NL-13-1460

Vogtle Electric Generating Plant – Units 1 and 2
Southern Nuclear Operating Company Response to the
Request for Additional Information Regarding Overall Integrated Plan for
Reliable Spent Fuel Pool Instrumentation (Order Number EA-12-051)

**Southern Nuclear Operating Company Response to the Request for Additional
Information Regarding Overall Integrated Plan for Reliable Spent Fuel Pool
Instrumentation (Order Number EA-12-051)**

SKETCH IN RESPONSE TO RAI ITEM 1.b

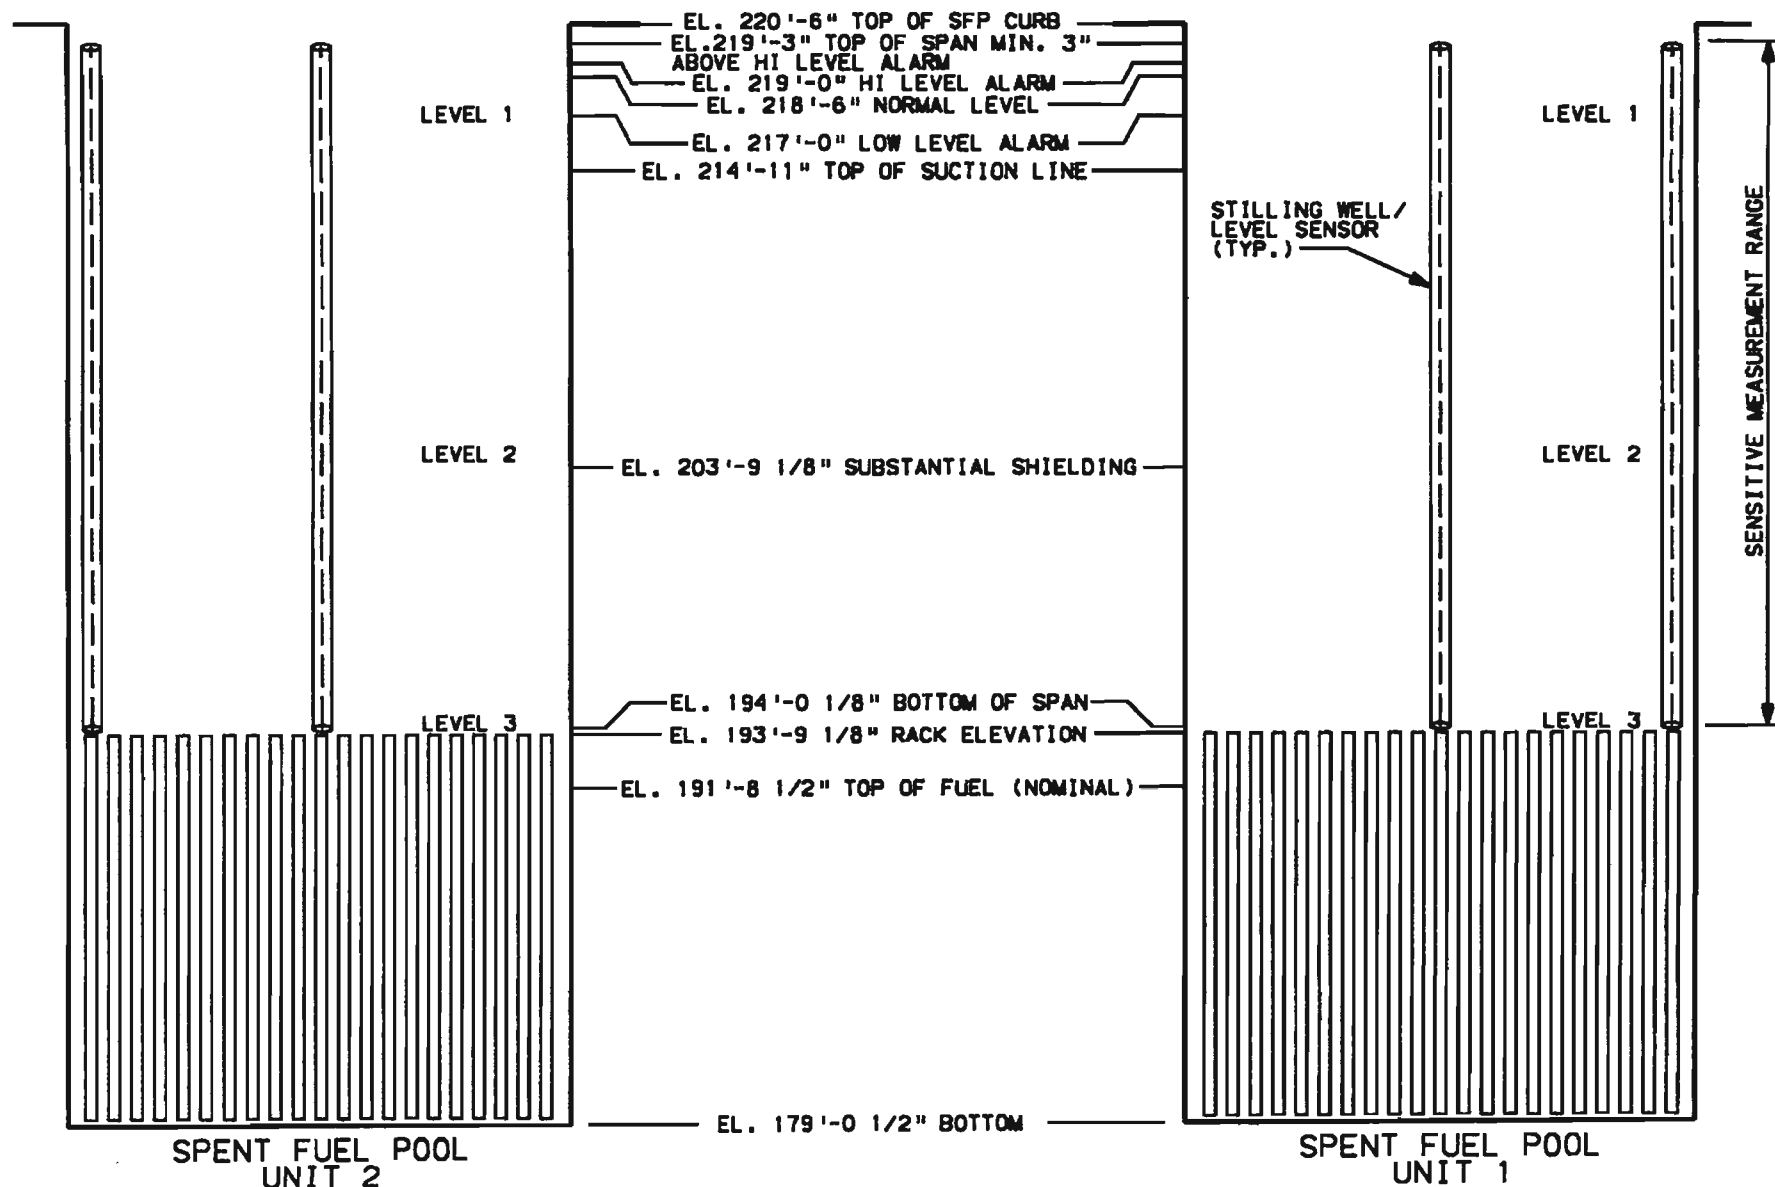
- a) For Level 1, specify how the identified location represents the HIGHER of the two points described in the NEI 12-02 guidance for this level.
- b) A clearly labeled sketch depicting the elevation view of the proposed typical mounting arrangement for the portions of instrument channel consisting of permanent measurement channel equipment (e.g., fixed level sensors and/or stilling wells, and mounting brackets). Indicate on this sketch the datum values representing Level 1, Level 2, and Level 3 as well as the top of the fuel. Indicate on this sketch the portion of the level sensor measurement range that is sensitive to measurement of the fuel pool level, with respect to the Level 1, Level 2, and Level 3 datum points.

Enclosure 2 provides a sketch that depicts an elevation view of the Unit 1 and 2 SFP. The sketch depicts the datum values representing Level 1, Level 2, and Level 3, as well as the top of the SFP rack. Per NEI 12-02, Level 3 corresponds nominally (i.e., +/- 1 foot) to the highest point of any rack seated in the spent fuel pool. The top of the fuel elevation that is shown on the sketch is a nominal value that varies depending upon the specific fuel assembly type and fuel bundle attachments. The level sensor sensitive measurement range will span from a minimum of 3 inches above the high SFP level alarm setpoint to 3 inches above the top of the spent fuel pool rack.

ATTACHMENT 2
RESPONSE TO
RAI ITEM 2
PG 10 OF 2

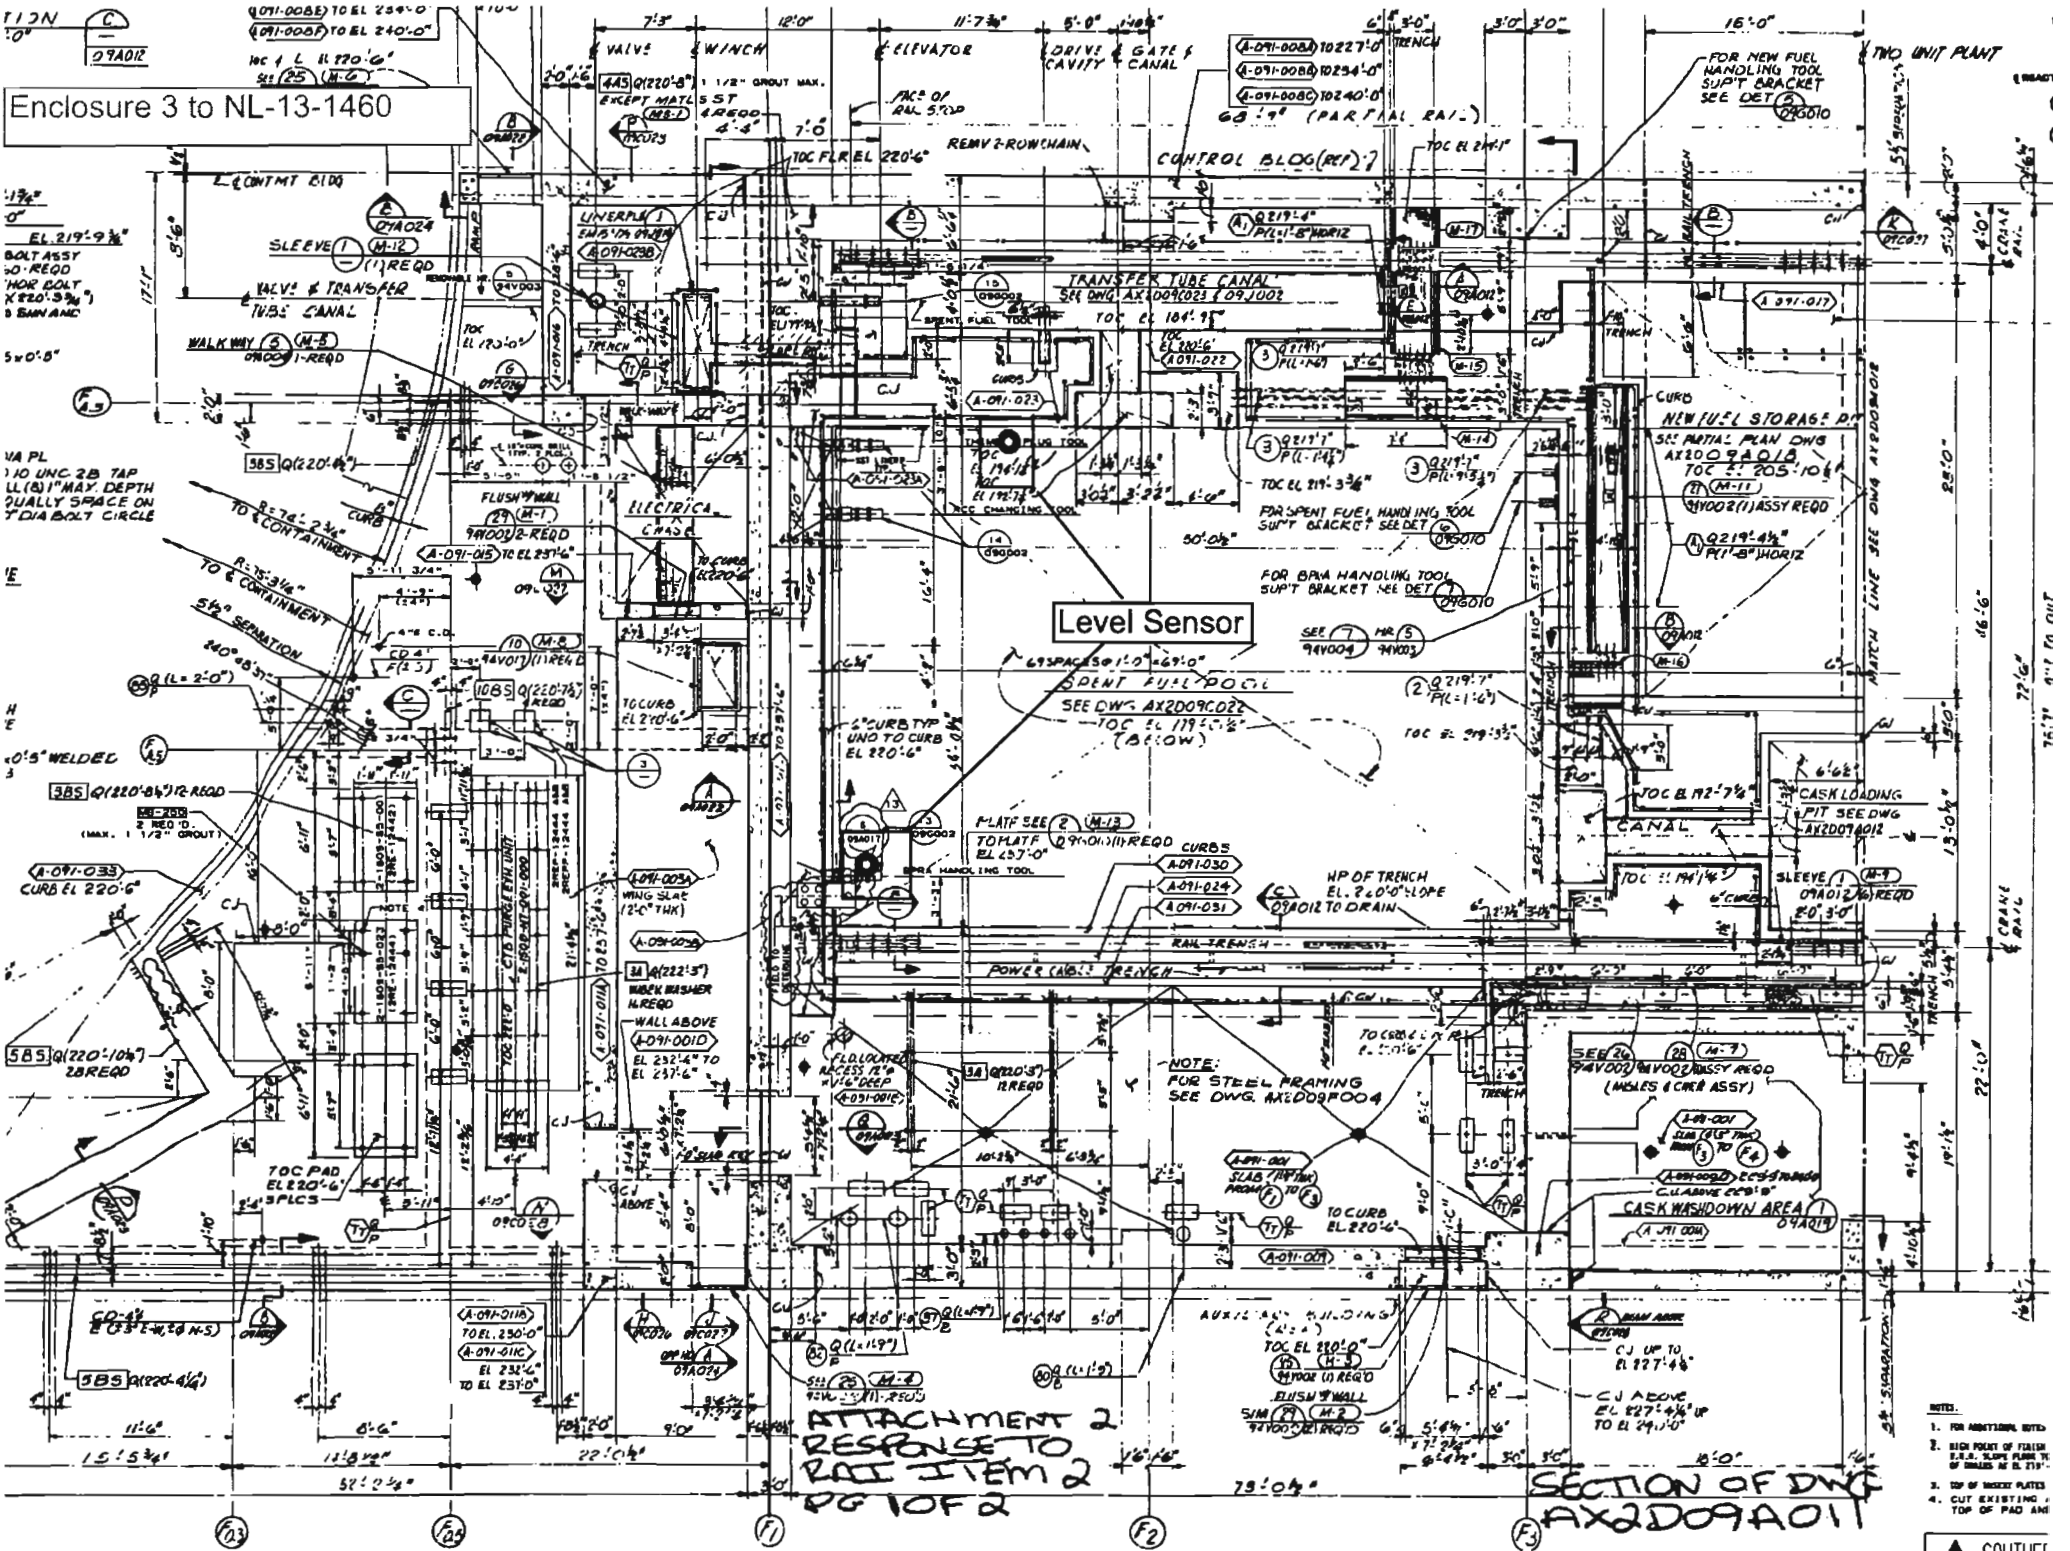
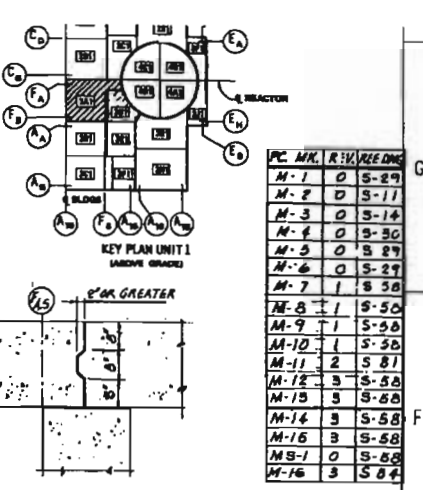
Please provide a clearly labeled sketch or marked-up plant drawing of the plan view of the SFP area, depicting the SFP inside dimensions, the planned locations/placement of the primary and back-up SFP level sensor and mounting brackets, and the proposed routing of the cables that will extend from the sensors toward the location of the read-out/display device.

Enclosure 3 depicts a section of marked up plant drawings AX2D09A011 and AX2D09A012. This attachment shows a plan view of the SFP area of each unit. The drawings show inside dimensions for the SFPs and the anticipated locations of the level sensors and associated mounting brackets (identified by the circle inside the square box). There is no designated primary or backup sensor as both serve an equal purpose. The routing of the instrument cables from the sensors to the display device will be determined after a location for the display unit has been finalized. SNC intends to provide specific SFP area cable routing information in the February 2014 Overall Integrated Plan 6 month update.
